Access Compliance Report

Public Rights-of-Way

(Curb Ramps)

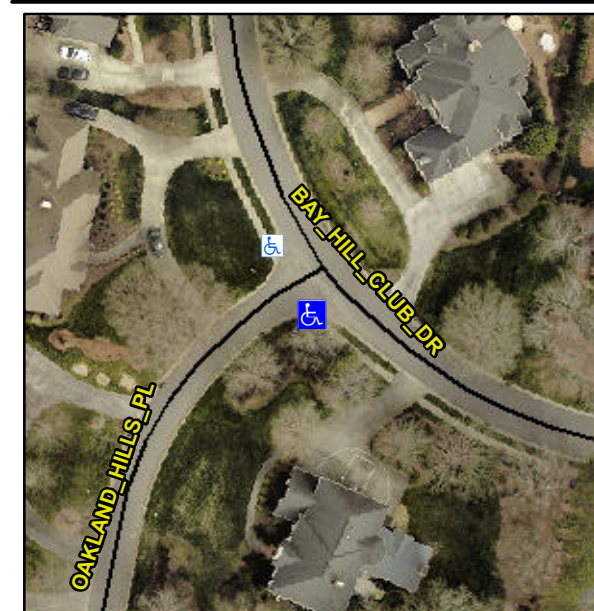
Not Found, R304.2.2

Compliance	Description	Data	Compliance	Description	Data
N/A	Ramp Length (in)	25.0	No	Ramp Slope (%)	10.0
Yes	Ramp Width (in)	96.0	Yes	Ramp XSlope (%)	0.6
N/A	Flare Type LT	N/A	N/A	Flare Type RT	N/A
N/A	Flare Slope LT (%)	N/A	N/A	Flare Slope RT (%)	N/A
N/A	Flare Traversable LT?	N/A	N/A	Flare Traversable RT?	N/A
N/A	Landing Length (in)	N/A	N/A	DWS Provided?	N/A
N/A	Landing Width (in)	N/A	N/A	DWS Contrast?	N/A
N/A	Landing Slope (%)	N/A	N/A	DWS Length (in)	N/A
N/A	Landing X Slope (%)	N/A	N/A	DWS Full Width?	N/A
N/A	Landing Curb? (Y/N)	N/A	N/A	DWS Offset (in)	N/A
N/A	Shared Landing?	N/A			
N/A	Gutter Ponding?	N/A	N/A	Gutter Slope (%)	N/A
N/A	Gutter Lip Ht (in)	N/A	N/A	Gutter X Slope (%)	N/A
N/A	Painted X Walk1?	No	N/A	Painted X Walk2?	N/A
	X Walk 1 Direction	To NW		X Walk 2 Direction	N/A
N/A	X Walk 1 Width (in)	N/A	N/A	X Walk 2 Width (in)	N/A
	X Walk 1 Slope (%)	3.0		X Walk 2 Slope (%)	N/A
	X Walk 1 X Slope (%)	0.1		X Walk 2 X Slope (%)	N/A

Remove & Replace Entire Ramp.
